City of Conway **HISTORIC DISTRICT COMMISSION**Agenda • July 22, 2019

NEW SINGLE-FAMILY RESIDENCE - 141 OLIVER STREET

NEW TWO-FAMILY RESIDENCE - 1415 PRINCE STREET

West Elevation

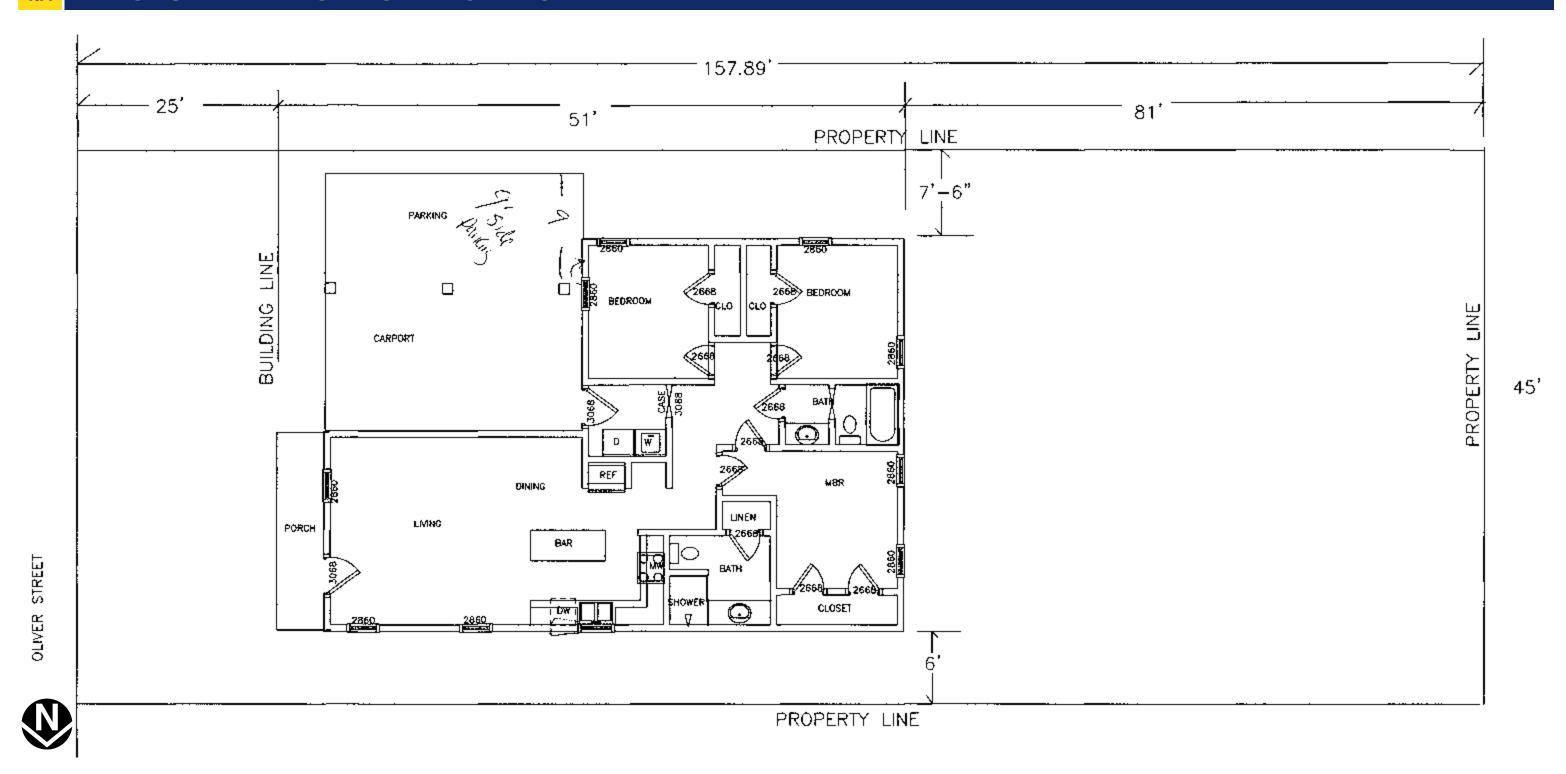
Entries, Porches, and Porticos, Doors and Windows, Awnings. The porch will be covered with a roof form that will relate appropriately to the house and adjacent structures. The window forms are appropriate, as proposed, but additional windows should be added along the side facades.

Recommend requiring dual windows for each bedroom on the south façade. Additionally, the discrepancy between the plan view and elevation view regarding windows on the rear facade should be corrected.

Shutters, Roof, Decks/Plaza Space, Skylights, Mechanical **Screening.** The applicant is proposing a hip style roof with asphalt shingles. The roof will have 6:12 pitch. The use of a hip roof on the shotgun front extension and wider main rear portion of the structure. This roof form will likely undercut the desired appearance of the structure.

Recommend requiring a transverse gable for the main portion of the house, which will help reinforce the cottage appearance of the house.

- 1. Driveway shall be paved with concrete, or appropriate pervious pavers. Dual ribbon driveways shall be required to mitigate the visual impact of the driveway's width.
- 2. A fee of \$877.06 be accepted in-lieu of sidewalk improvements due to the lack of sidewalks in the area.
- 3. Require a transverse gable for the main portion of the house.
- 4. HVAC equipment be placed in a manner to minimize its visibility from the street.
- 5. The applicant will provide revised plans to the Planning Director for review and approval prior to issuance of building permits. This shall include resolving discrepancies between the plan view and elevations.

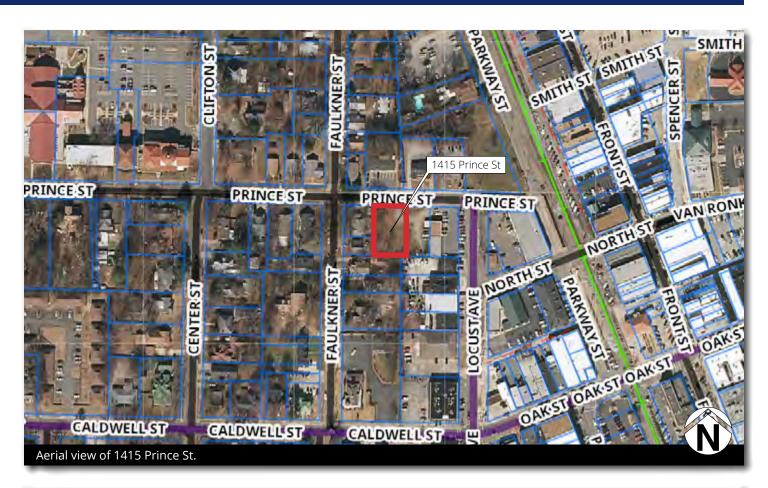
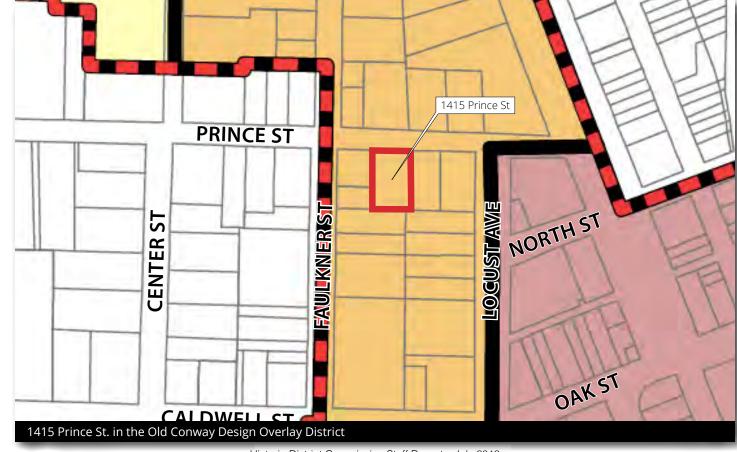
The structure will contain a level of detailing and form that is not consistent with surrounding structures. The structure's detailing should be revised to increase its compatibility with surrounding structures.

As proposed, the front façade of the structure will be dominated by various features not often seen along front facades such as chimneys. There are fewer window openings than seen within the general area. Recommend the front façade designed be altered in a manner to make it more generally consistent with the surrounding area this would include removal of features such as chimneys, increasing the number of windows, and altering the articulation of the front façade to be more consistent with forms

The style of the structure will be modern vernacular. The structure does not appear compatible with the surrounding historic forms, but could be modified to be more in keeping with the area. Recommend requiring an update of the front façade design.

Entries, Porches, and Porticos, Doors and Windows, Awnings. The porch should have a depth of at least 6 ft. and contain a roof of materials similar to the main roof. The depth of the front should be increased to be between 6-10 ft. The metal roofing over the porch should be removed or made to be standing seam.

- 1. Redesign of the front façade to remove elements such as chimneys, increase the number of window openings, increase the depth of the porch, alter front façade articulation, require removal of metal roofing or require standing seam, and modify the appearance of roof forms to respect more historical norms and to reduce massing.
- 2. Remove or reduce the amount of stone veneer on the front façade.
- 3. Decrease the front setback to 18' or less.
- 4. Indicate planting for 3 canopy trees such as a Willow Oaks. Consult with planning staff for a list of approved trees.
- 5. Repair the existing sidewalk.

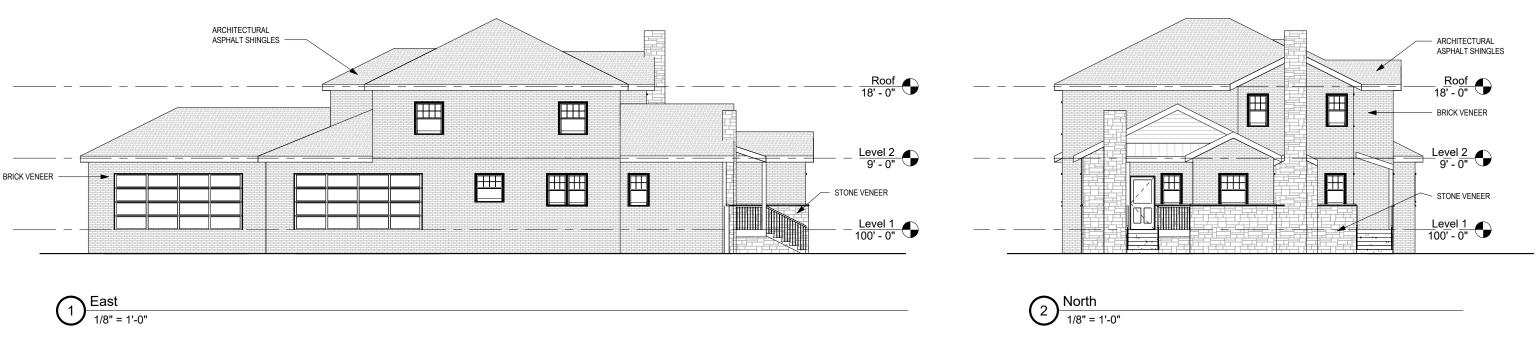
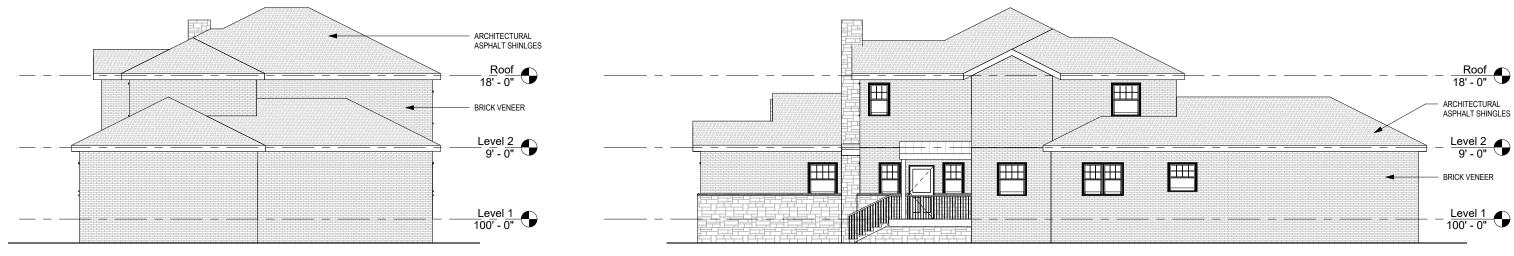
The roof form conveys a contemporary style that is not

consistent with the surrounding area. Additional gables and or reduced use of hipped roofing would make the design more appropriate.

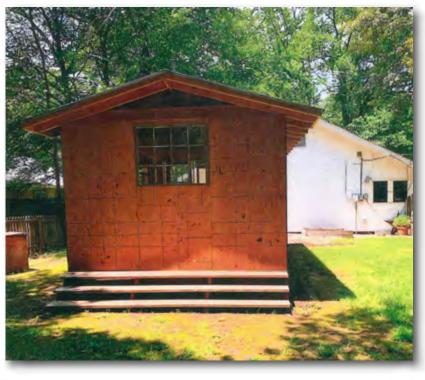
Siding and Brick. The use of vinyl siding is not permitted. Siding should consist of finished wood siding, Hardie board, brick, or stone.

The applicant proposes vinyl siding. Use of wood, Hardie board, brick, or stone shall be made a condition of approval.

- 1. The structure shall be clad in finished wood siding, Hardie board, brick, or stone.
- 2. The applicant shall provide updated plans for approval by the Planning Director prior to issuance of the Certificate of Appropriateness.
